Browns Summit Creek Restoration Project Year 7 Monitoring Report/Closeout Report

DMS Project ID No. 96313, DEQ Contract No. 5792

Subject: Response to Task 13 Draft Year 7 Monitoring/Closeout Report Comments for
Browns Summit (DMS #96313) Cape Fear River Basin; CU 03030002;
Guilford County, North Carolina Contract No. 005792

Figure	4.1 & 4.2	Current Condition Plan View
Table	5	Visual Stream Morphology Stability Assessment
Table	6	Vegetation Conditions Assessment
Stream Station Photos		
Additional Photos		
Vegetation Plot Photos

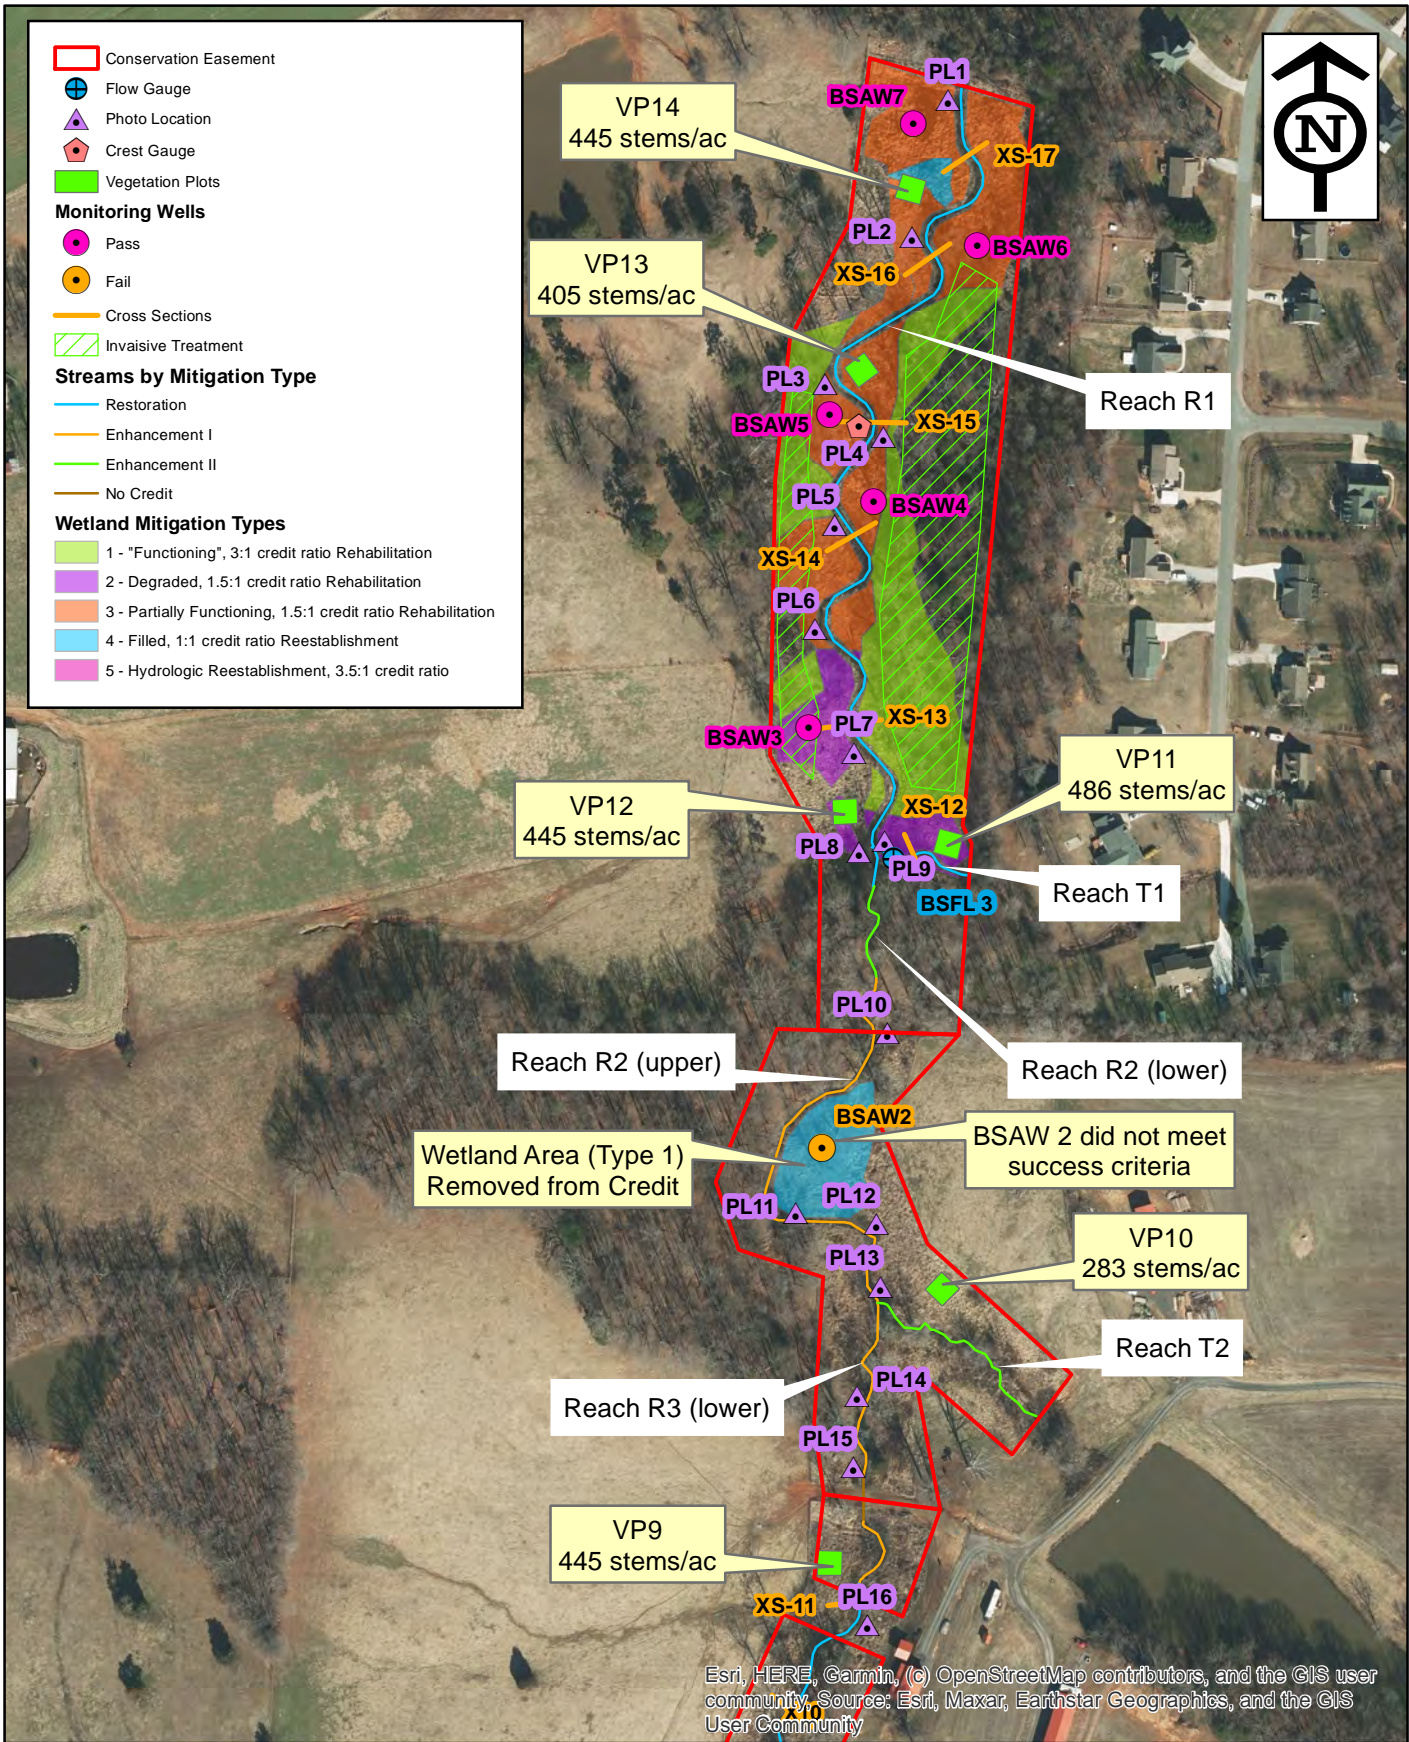
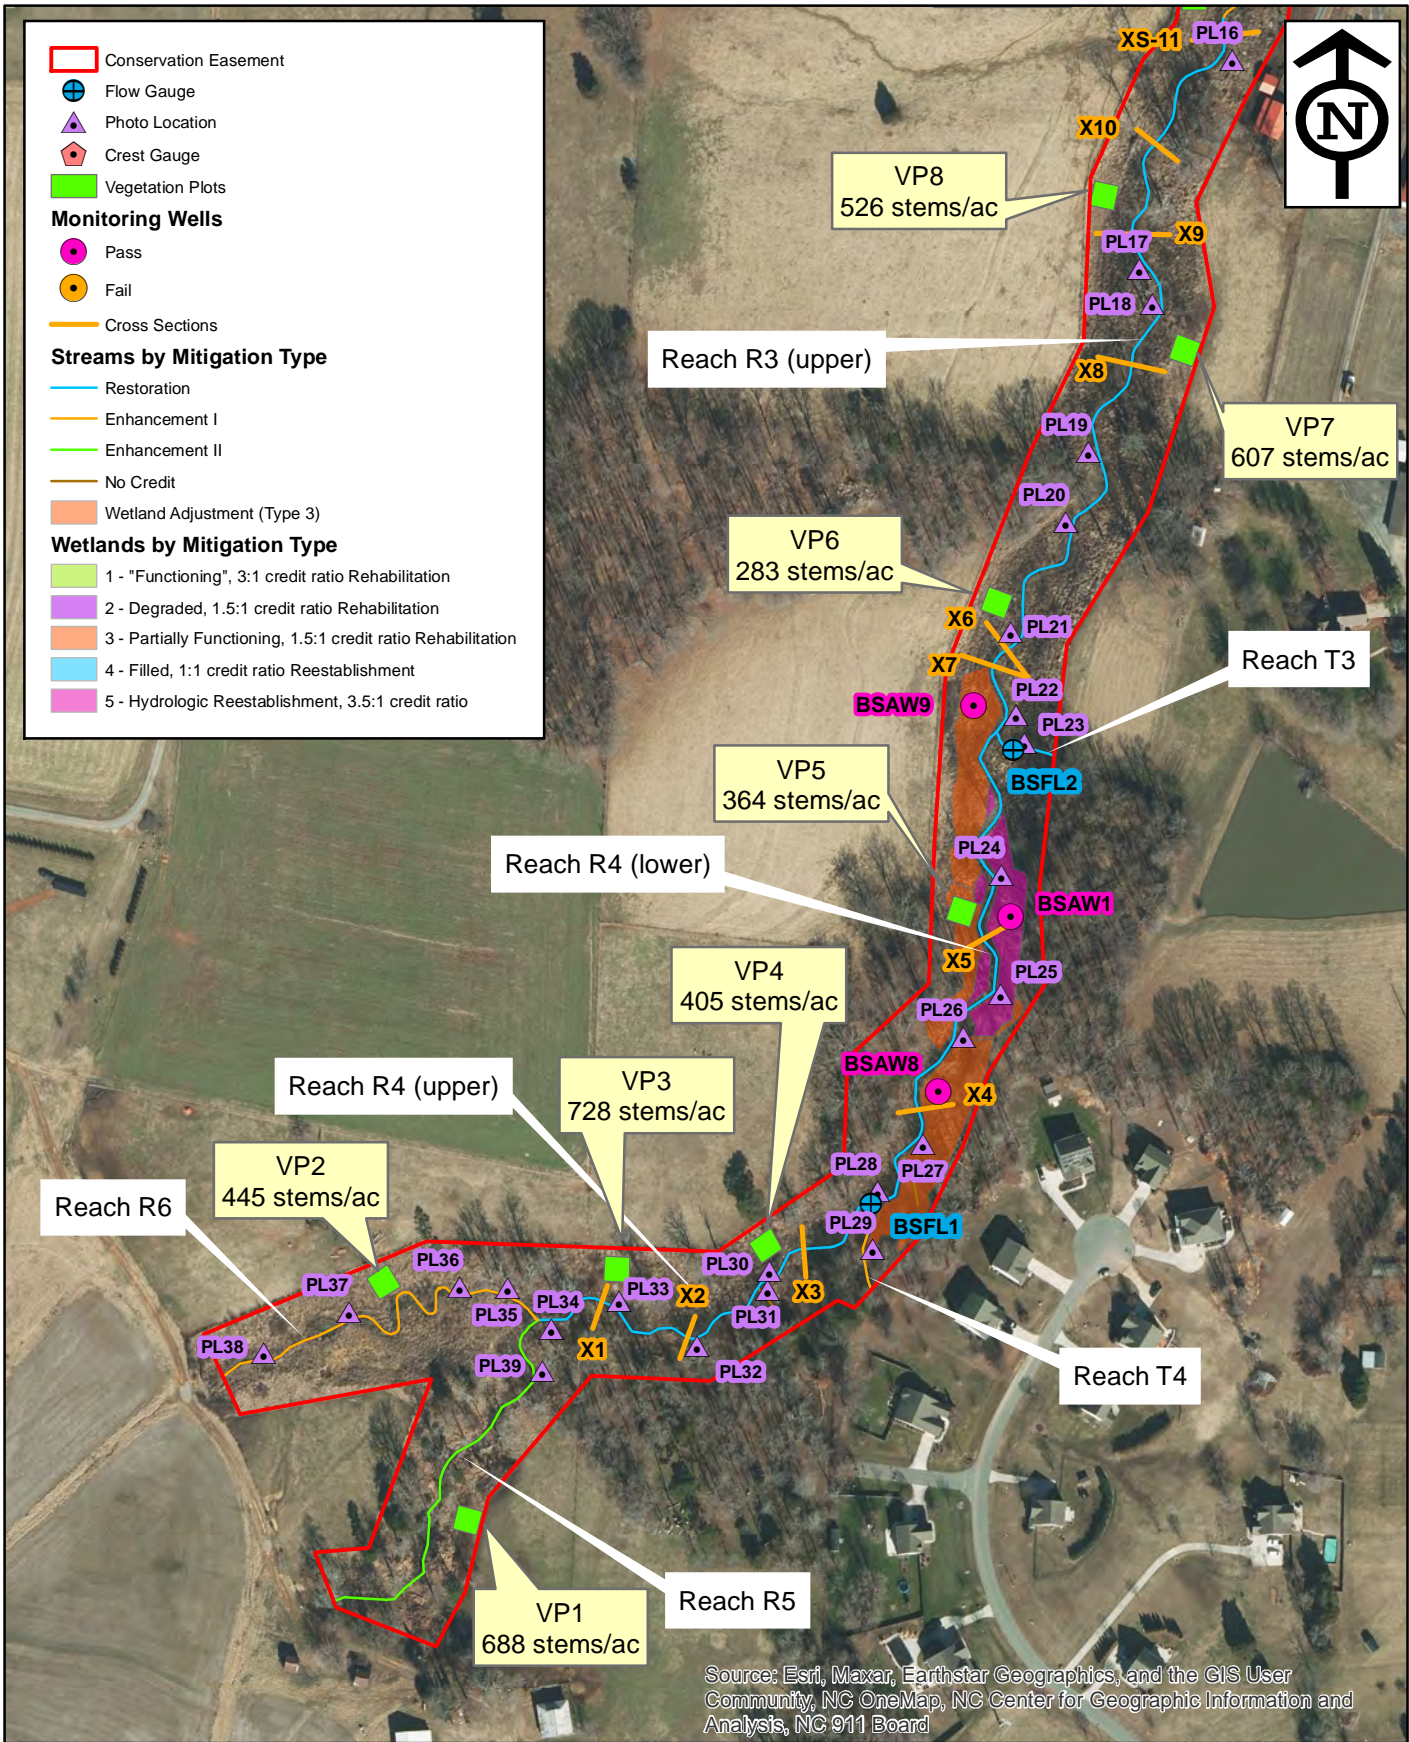
Comment: Figure 4.1 and 4.2: Please include the additional wetlands on the CCPV and note the wetland be removed from credit.

Response: Revision made as requested.

Permanent Cross-section 8
(Year 7 Data - Collected September 2023)

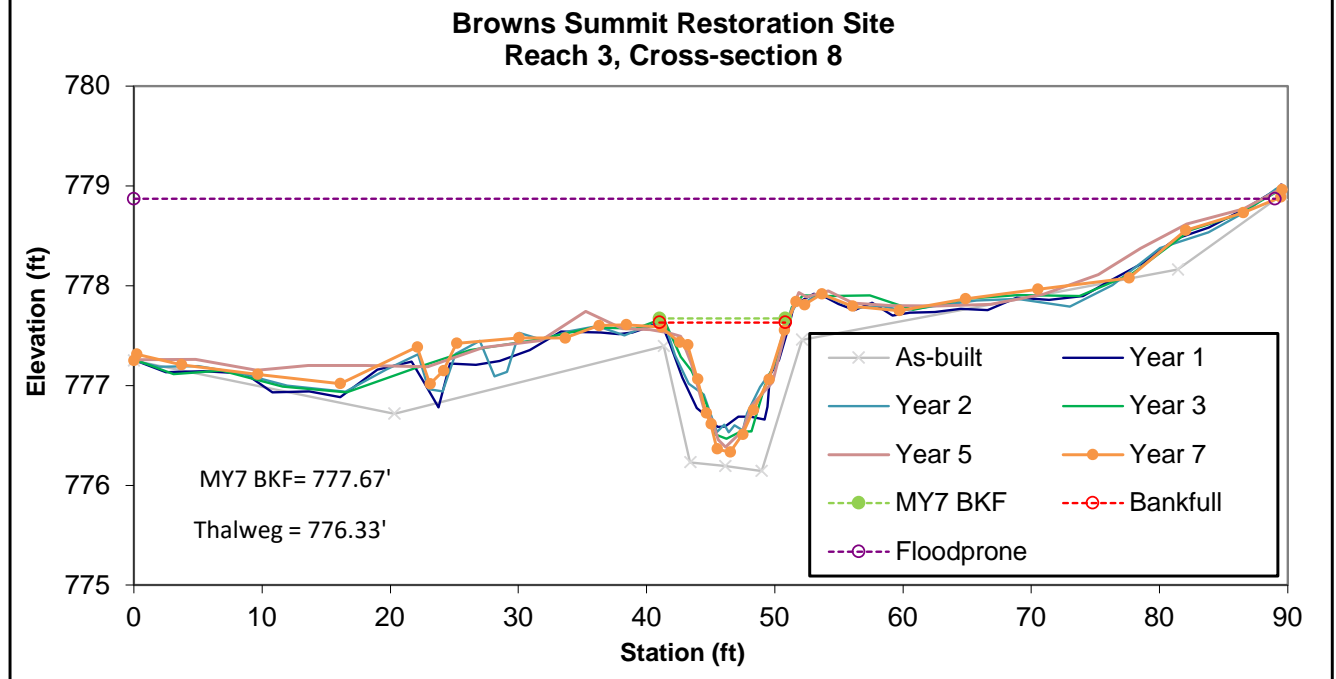
Comment: Appendix D: One of the photos associated with cross-section 8 is not displaying correctly; please update

Response: Revision made as requested.

Browns Summit Creek Restoration Project MY7 Observed Rainfall versus Historic Averages

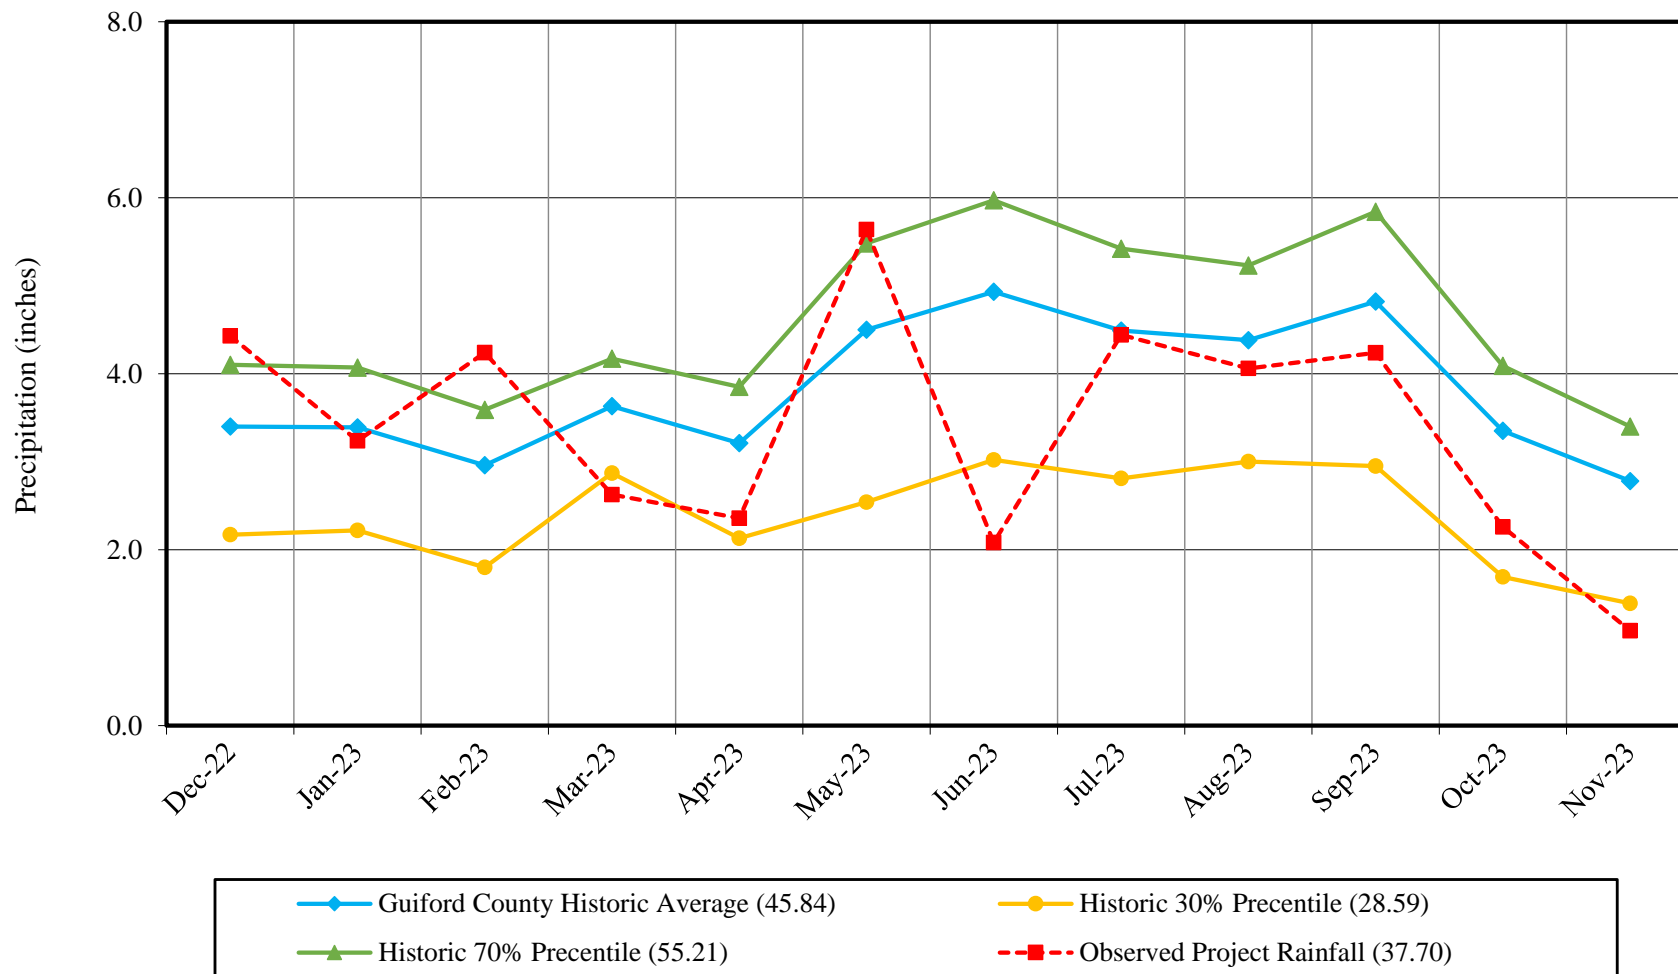
Comment: Appendix E, Rainfall Graph: Please update rainfall data to include any monthly rainfall up to final submission.

Response: Revisions have been made as requested.
